**MONTGOMERY COUNTY HISTORIC PRESERVATION COMMISSION**  
**STAFF REPORT**

<b>Address:</b>	6403 Connecticut Avenue, Chevy Chase	<b>Meeting Date:</b>	10/14/2020
<b>Resource:</b>	Contributing Resource (Chevy Chase Village Historic District)	<b>Report Date:</b>	10/7/2020
		<b>Public Notice:</b>	9/30/2020
<b>Applicant:</b>	Jessica Killin	<b>Tax Credit:</b>	N/A
<b>Review:</b>	HAWP	<b>Staff:</b>	Michael Kyne
<b>Case Number:</b>	35/13-20CC		
<b>PROPOSAL:</b>	Driveway alteration

**Fig. 2: March 23, 2016 proposal.**

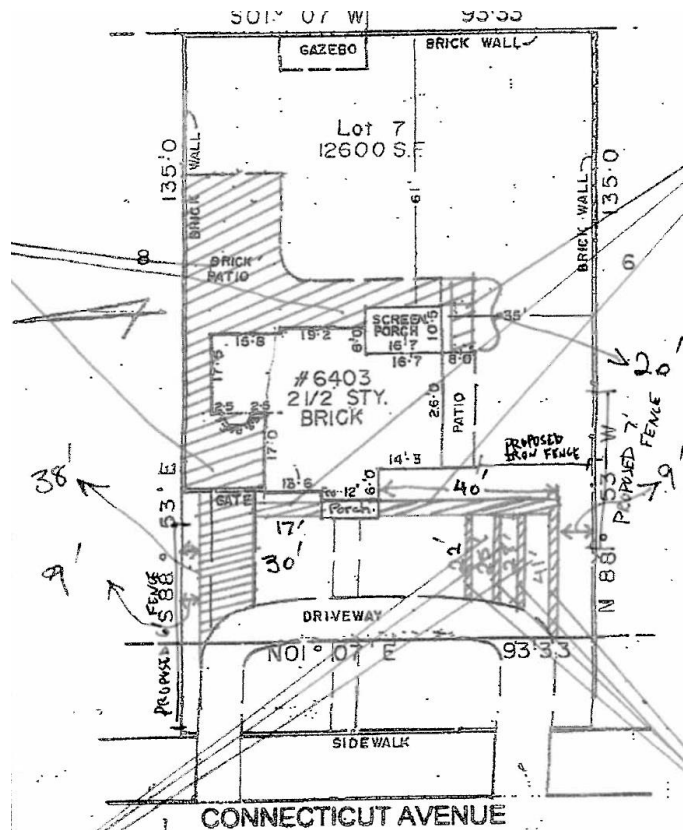
Staff notes that the Commission previously reviewed a proposal for a parking pad and driveway ribbon installation at the subject property at the March 23, 2016 HPC meeting (see attached meeting transcript). At that time, the previous owner proposed to install a solid parking pad at the north (left) side of the existing semicircular driveway and a total of four driveway ribbons at the south (right) side of the driveway (see Fig. 2 below). The parking pad at the north (left) side of the driveway was being proposed to provide both parking and catering van access, and the four driveway ribbons at the south (right) side of the driveway were being proposed to provide parking for two additional vehicles.

Staff recommended that the proposed parking pad and driveway ribbons not be approved. However, the Commission approved the proposal with the condition that the parking pad at the north (left) side of the driveway be driveway ribbons, and the driveway ribbons at the south (right) side of the driveway were not approved. Staff's recommendation and the Commission's decision were largely based upon the *Guidelines*, which state "[p]arking pads and other paving in front yards should be discouraged."

The Commissioners were generally consistent in stating that a ribbon driveway extension on the south (right) side of the existing driveway that provides access to a garage and/or a larger parking area at the rear of the property would be appropriate, as it would be in keeping with the typical driveway location/design in the Chevy Chase Village Historic District. This statement was partly due to the spacing at the south (right) side of the property. The applicant was given an opportunity to continue the case to next HPC meeting and make revisions, but he declined.

Staff recommends that the Commission consider the current proposal, given their comments regarding a traditional driveway at the south (right) side of the property, and the reduction in scope of the proposed driveway ribbons at the south (right) side of the existing driveway (going from four ribbons to a more traditional two ribbons).

**HOUSE LOCATION SURVEY**

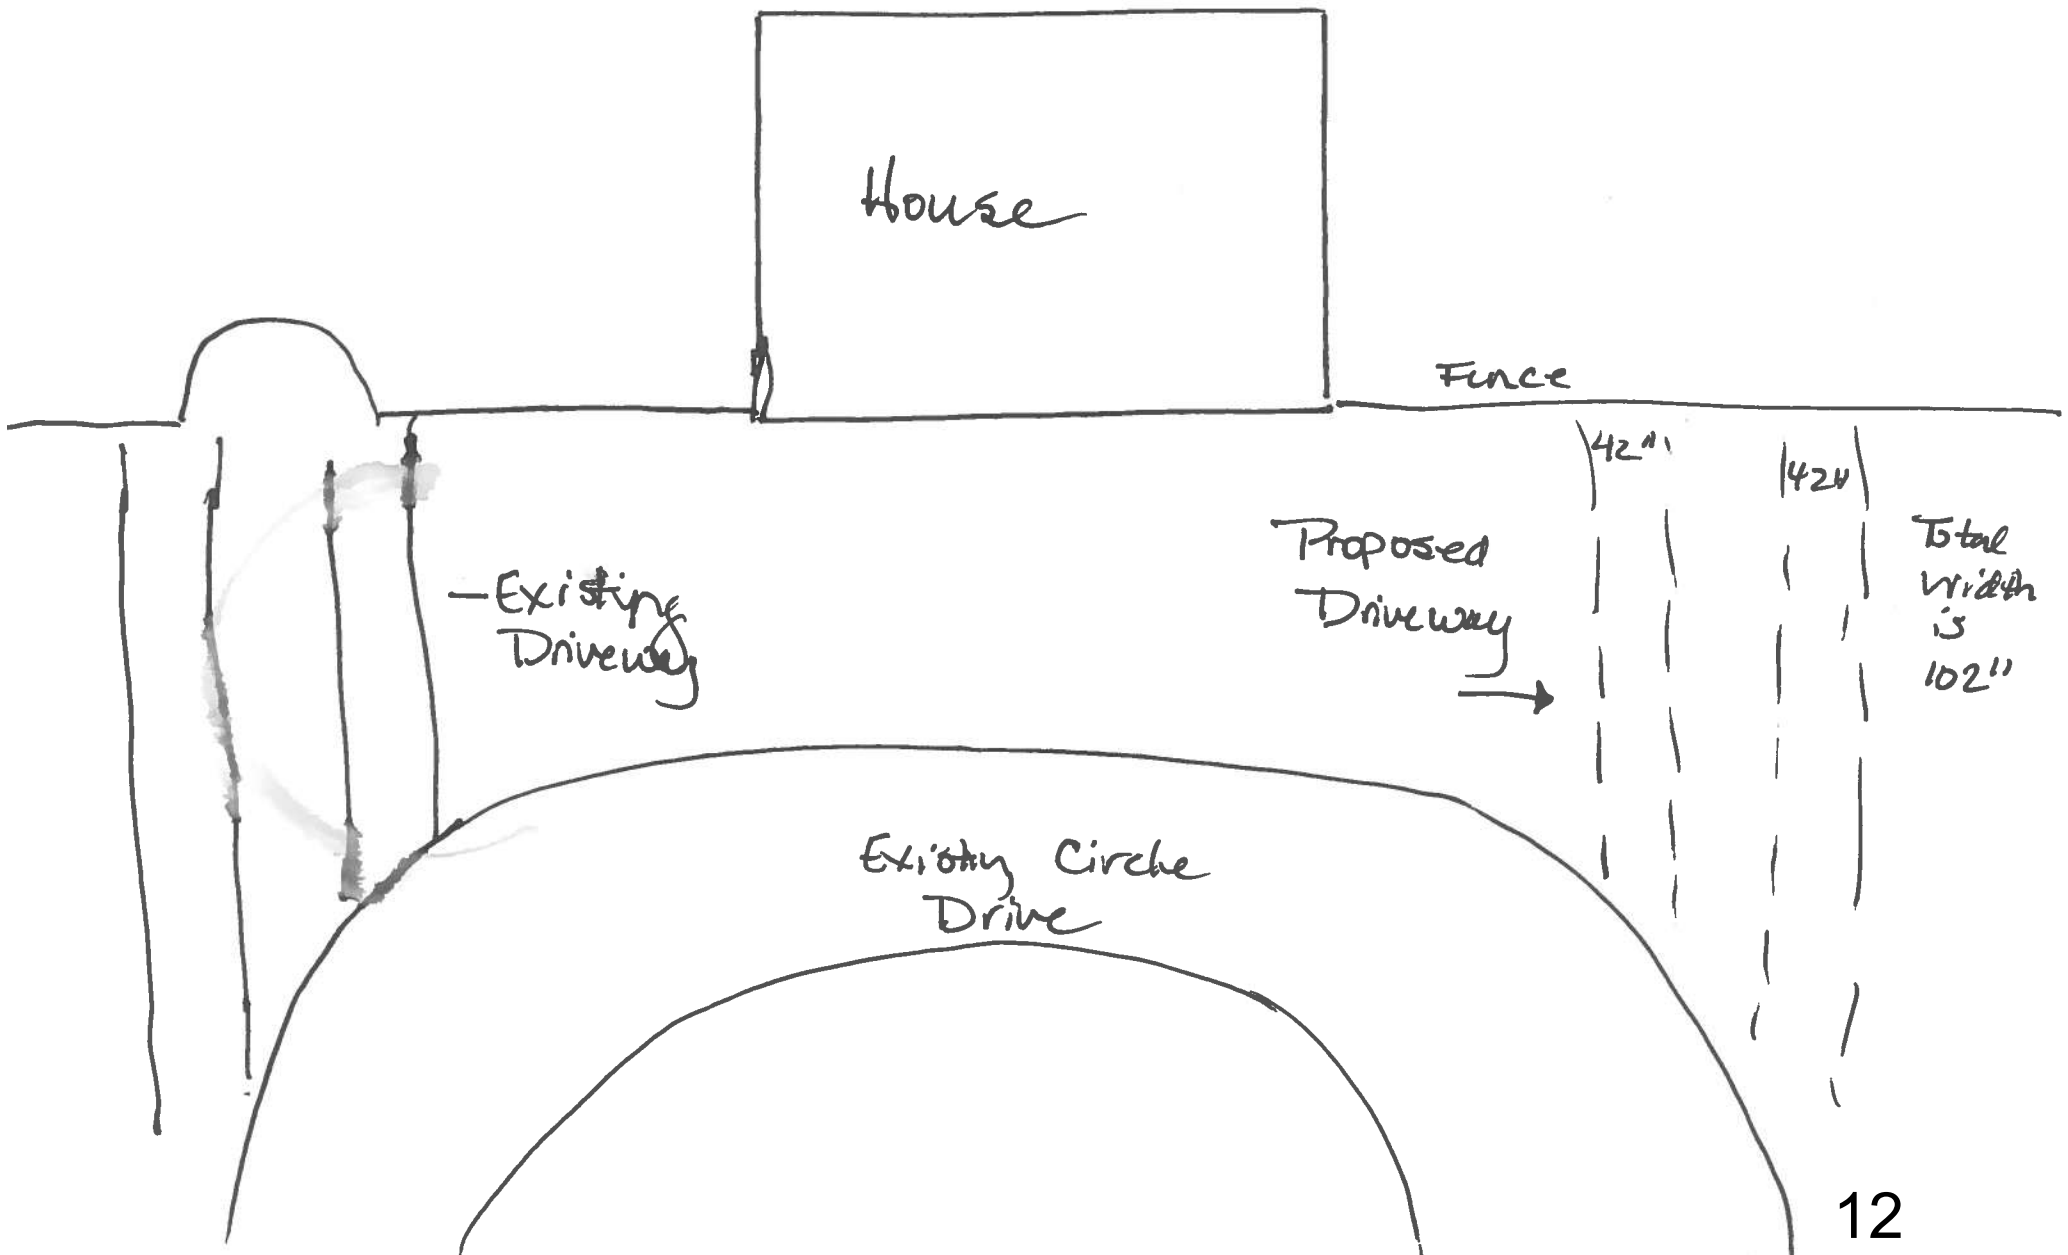
The applicant proposes to construct a parking pad/driveway ribbons at the south (right, as viewed from the public right-of-way of Connecticut Avenue) side of the existing semicircular driveway at the front (west side) of the property. The proposed parking pad/driveway ribbons will match those at the north (left) side of the driveway in design and material (concrete with exposed pebble stone).

- The amount of proposed new hardscaping is minimal, as opposed to a full driveway extension to the rear of the property.
- The proposed ribbons will match those previously approved at the north (left) side of the existing semicircular driveway, providing greater symmetry.

- The proposed driveway ribbons could be extended in the future, incorporating the Commission's previous suggestion to provide parking at the rear of the property via a driveway extension at the south (right) side of the property.

- As noted by the Commission at the March 23, 2016 HPC meeting, the greatest impact to the surrounding streetscape will be parked vehicles at the front of the subject property, which could detract from the Village's park-like setting. However, staff notes that, even without the proposed driveway ribbons/parking pad, vehicles will park at the front of the property on the existing driveway. Also, this impact is temporary and entirely dependent upon vehicles being present.

After full and fair consideration of the applicant's submission staff finds the proposal, as revised, as being consistent with the Criteria for Issuance in Chapter 24A-(b) 1 and 2, having found the proposal is consistent with the *Secretary of the Interior's Standards for Rehabilitation #2, #9, and #10*, and *Chevy Chase Village Historic District Guidelines* outlined above.

Staff recommends that the Commission **approve** the HAWP application only for alterations to the main house under the Criteria for Issuance in Chapter 24A-8(b)(1), (2), and (d), having found that the proposal is consistent with the *Chevy Chase Village Historic District Guidelines* identified above, and therefore will not substantially alter the exterior features of the historic resource and is compatible in character with the district and the purposes of Chapter 24A;
